PROPOSAL FOR DRAFT AMENDMENT TO REGULATION No. 17
VEHICLE SEATS, THEIR ANCHORAGES AND ANY HEAD RESTRAINTS

A. PROPOSAL

Figure 1

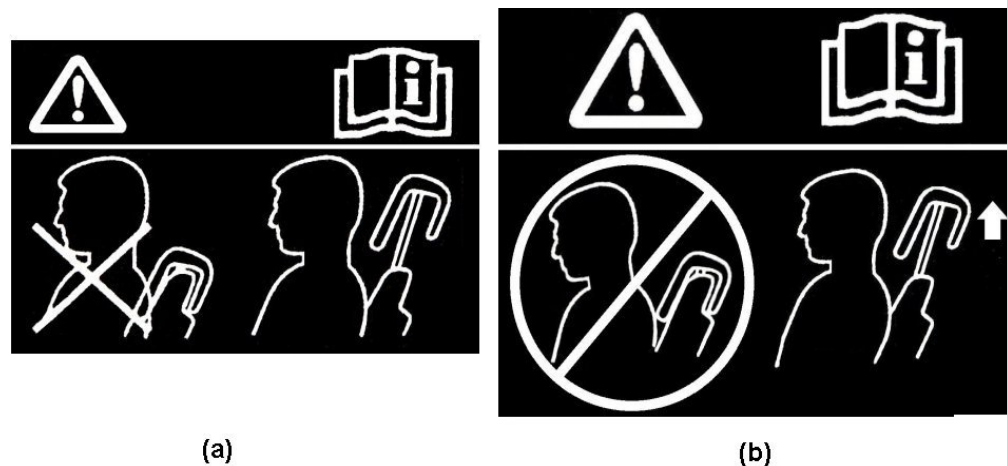
- 5.8.4.5. The head restraint shall be marked with a label in the form of a pictogram which may include explanatory text. The label shall either provide an indication when the head restraint is in a non-use position or provide information to enable an occupant to determine whether the head restraint is in a non-use position. The label shall be durably affixed and located such that it is clearly visible by an occupant when entering the vehicle to the designated seating position. Examples of possible designs are shown in Figure 1.

Figure 1-1

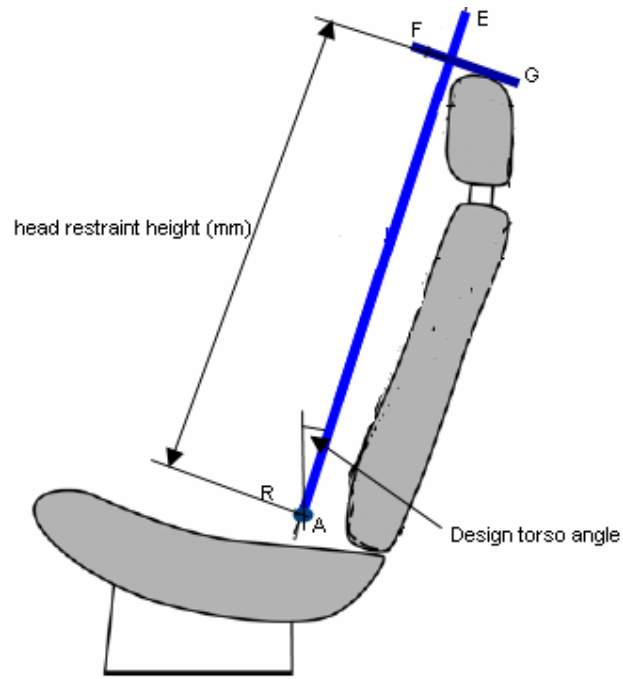
The height measurement apparatus consists of (see Figure 1-1):

2.2.1. A straight edge AE. The lower point A is placed at the R point location in accordance with paragraph 2.1 of this Annex. The line AE shall be parallel to the design torso angle.

2.2.2. A straight edge FG, perpendicular to the line AE and in contact with the top of the head restraint. The height of the head restraint shall be the distance between point A and the intersection of the lines AE and FG.

Figure 2-1

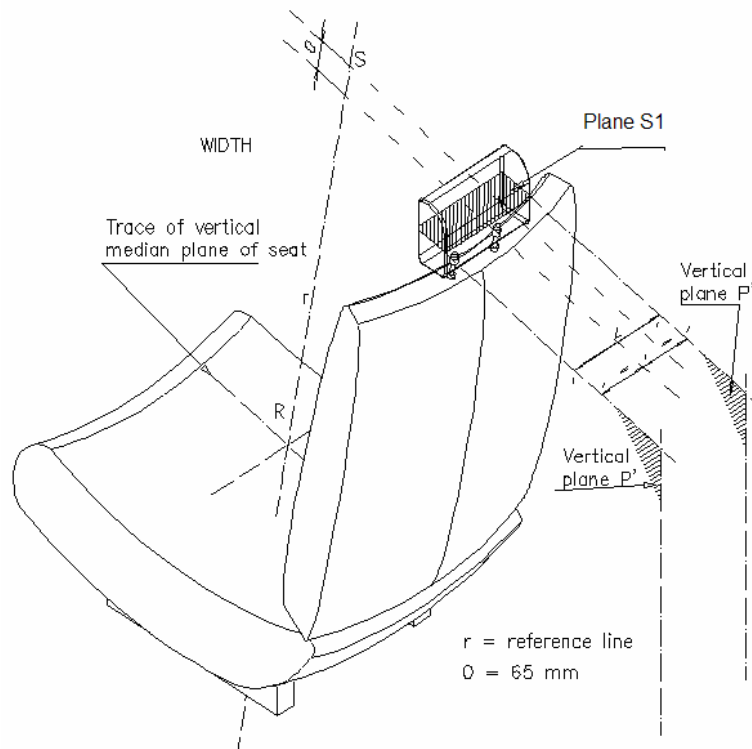
2.2. The plane S1 is a plane perpendicular to the reference line and situated 65 ± 3 mm below the top of the head restraint.

2.3. Planes P and P' are vertical longitudinal planes, tangent to each side of the head restraint to be measured.

2.4. The width of the head restraint to be taken into consideration is the distance L, measured in the plane S1 between the vertical longitudinal planes P and P'.

Figure 3-1

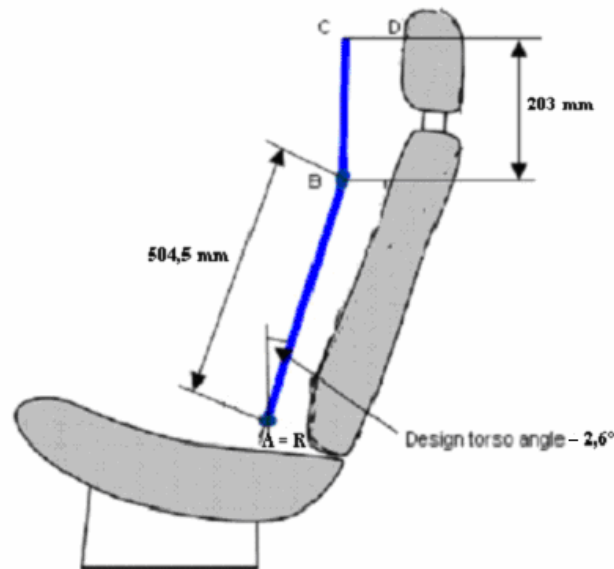
The backset measurement apparatus consists of (see Figure 3-1):

- 3.6. Establish point D on the head restraint, point D being the intersection of a line drawn from point C horizontally in the X direction, with the front surface of the head restraint.

- 3.7. Measure the distance CD. The backset shall be the measured distance CD minus 71 mm.

Figure 7-1.

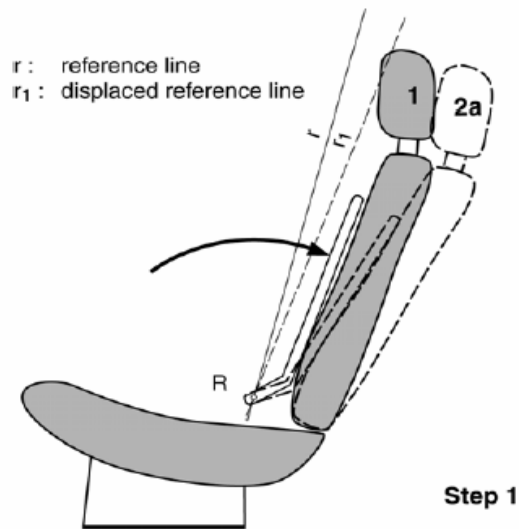
2.3. Establish the displaced torso reference line 'r' by creating a rearward moment of 373 ± 7.5 Nm about the R-point by applying a force to the seat back through the back pan at the rate of 2.5 Nm/second to 37.3 Nm/second. The initial location on the back pan of the moment generating force vector has a height of $290 \text{ mm} \pm 13 \text{ mm}$. Apply the force vector normal to the torso reference line and maintain it within 2 degrees of a vertical plane parallel to the vehicle longitudinal centreline. Constrain the back pan to rotate about the R-point. Rotate the force vector direction with the back pan. (see Figure 7-1)

- (1) Position 1. Original unloaded position.
- (2) Position 2a. Displaced position by applying to the manikin's back a moment of 373 Nm about the R-point, defining the position of the displaced torso reference line 'r₁'.

Figure 7-2.

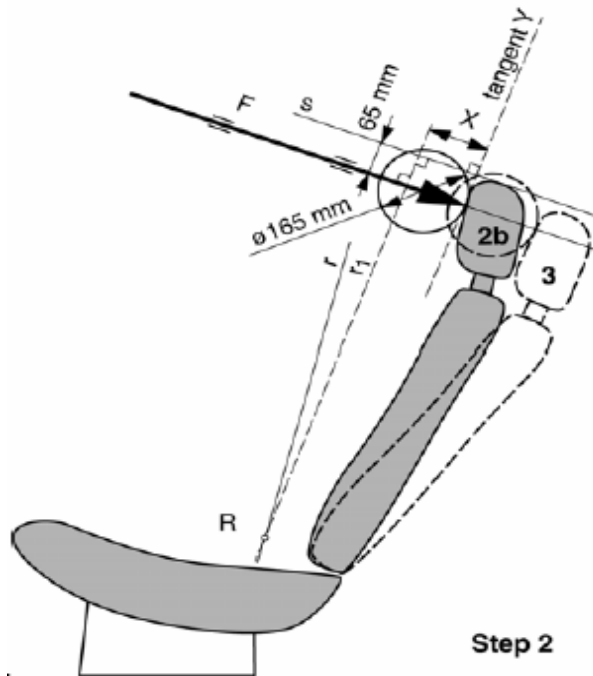
2.4. Maintain the position of the back pan as established in paragraph 2.3. of this annex. Using a 165 ± 2 mm diameter spherical head form with a surface roughness of less than $1.6 \mu\text{m}$, root mean square, establish the head form initial reference position by applying, perpendicular to the displaced torso line, a rearward initial load at the seat centreline at a height 65 ± 3 mm below the top of the head restraint that will produce a 36.5 ± 0.5 Nm moment about the R-point. When determining the rearward displacement for head restraints at a gap greater than 60 mm in accordance with paragraph 5.5.4 of this regulation, the above load shall be applied through the centre of gravity if the smallest of the sections of the gap, along transversal planes parallel to the torso line. (see Figure 7-2)

- (3) Position 2b. Displaced position by applying to the 165 mm sphere a force F producing a moment of 373 Nm about the R-point, keeping the displaced torso reference line 'r1' in place.

Figure 9-1.

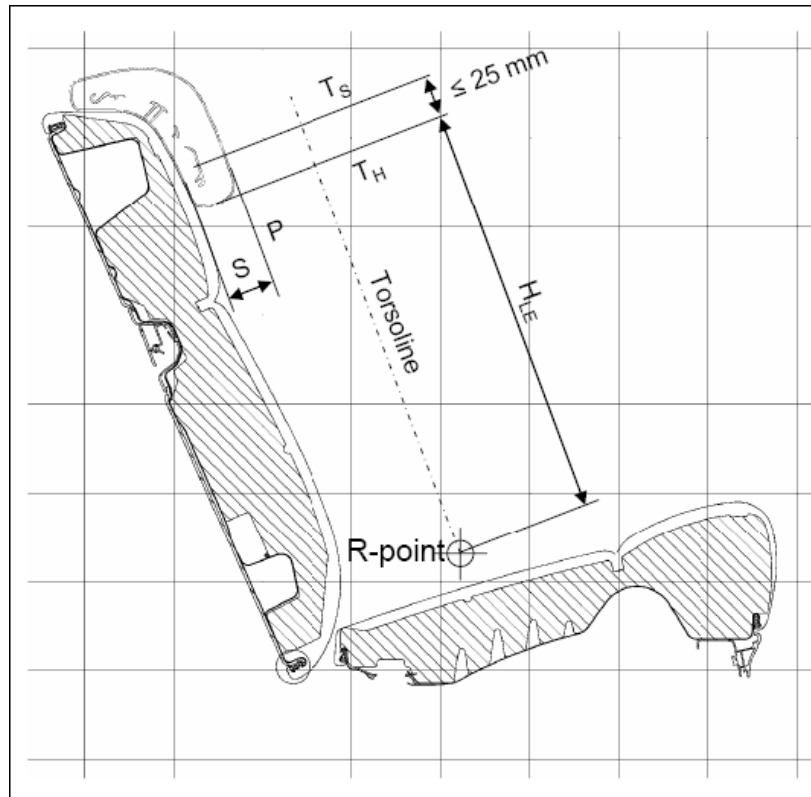
4.1. The H_{LE} and S dimensions are defined in Figure 9-1. which shows a vertical fore-aft plane passing through the R-point (i.e. at the mid point of the designated seating position) intersecting the seat cushion, seat back and the head restraint.

4.2.4. T_H is the line perpendicular to the torso line and tangent to the lower edge of the head restraint.

4.2.5. T_S is the line parallel to and 25 mm from T_H .
